# ASCM Replacement

DATE: February 8, 2024

**MODEL:** Levante M161 (All MY)

**SECTION:** 06.90 - 1 ELECTRONIC CONTROL (SUSPENSION)

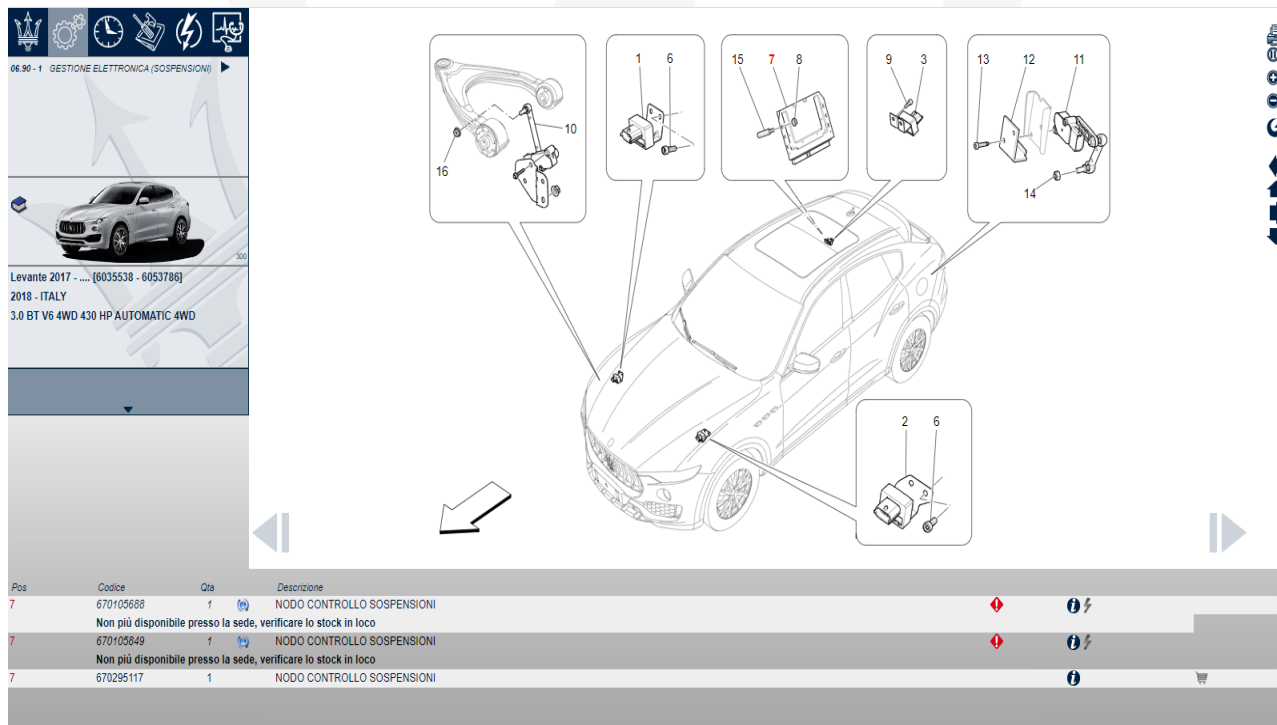
Pos	Codice	Qta	Descrizione		
7	670105688	1	NODO CONTROLLO SOSPENSIONI Non più disponibile presso la sede, verificare lo stock in loco	⚠	🔧
7	670105849	1	NODO CONTROLLO SOSPENSIONI Non più disponibile presso la sede, verificare lo stock in loco	⚠	🔧
7	670295117	1	NODO CONTROLLO SOSPENSIONI		🔧

**ACTION:** If it becomes necessary to replace the ASCM module on M161 for any reason, proceed as follows:

- **For M161 from MY 17 to 20:** (included) Open a BOL as "SUPPORT REQUEST" and note that you are requesting to replace the ASCM (Example: "Opening a BOL to request correct ASCM SW for MY17 to 20"). **Do not perform any ASCM updates unless requested by the BOL specialist.**
- **For M161 from MY 21 onwards:** Proceed as per the procedure in the workshop manual (Procedure 06.90.001 - 00 "SHOCK ABSORBER ECU - Removal/refitting or replacement")
